## TECHNICAL BULLETIN

### GENERAL REQUIREMENTS FOR OFF ROAD VEHICLES

Addition of an alternate safety cage main hoop design and addition of alternate front window bar configuration.

(f) Main hoop reinforcement variation: the following variations to the diagonal braces in the main hoop are acceptable:

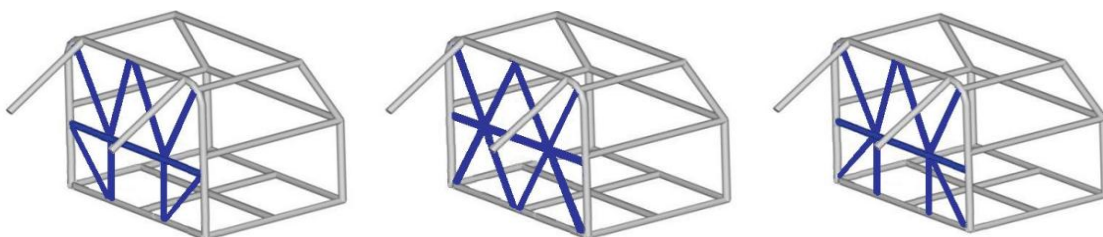
*Amend: General Requirements for Off Road Vehicles, Article 2.2 (f)*

*The following options are acceptable alternatives subject to CAMS certification and a satisfactory engineers report.*

**3.3 Front window opening bracing options:**

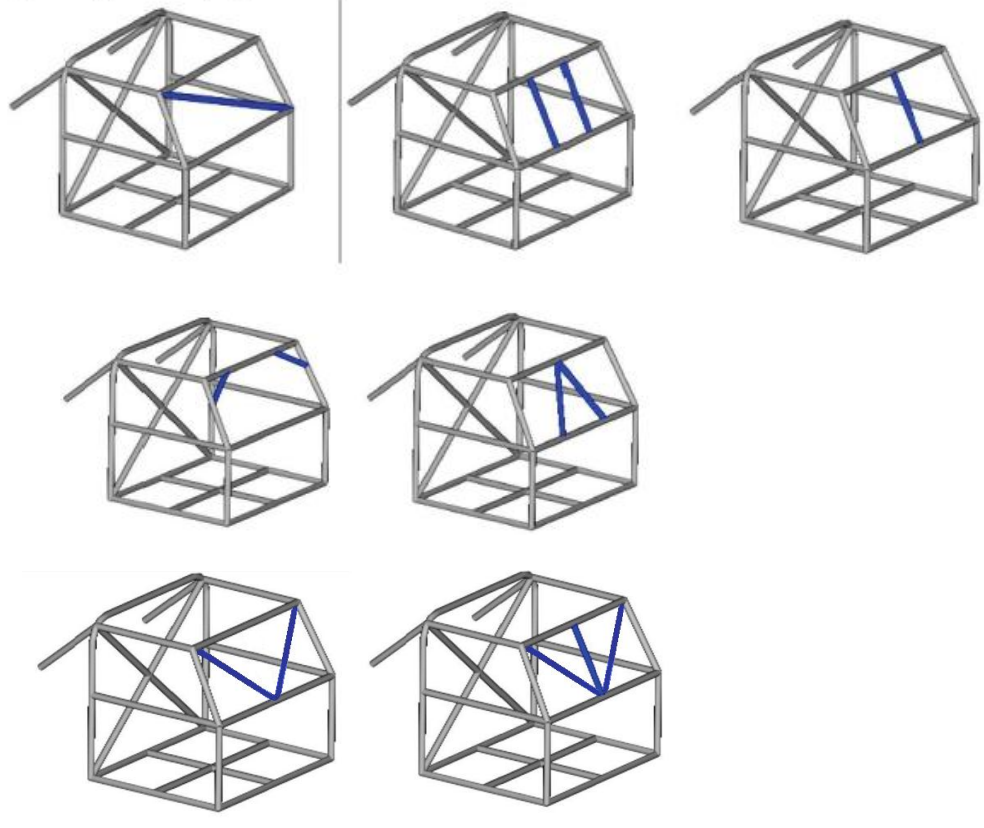
*Amend: General Requirements for Off Road Vehicles, Article 3.3, Front Window Opening Bracing Options*
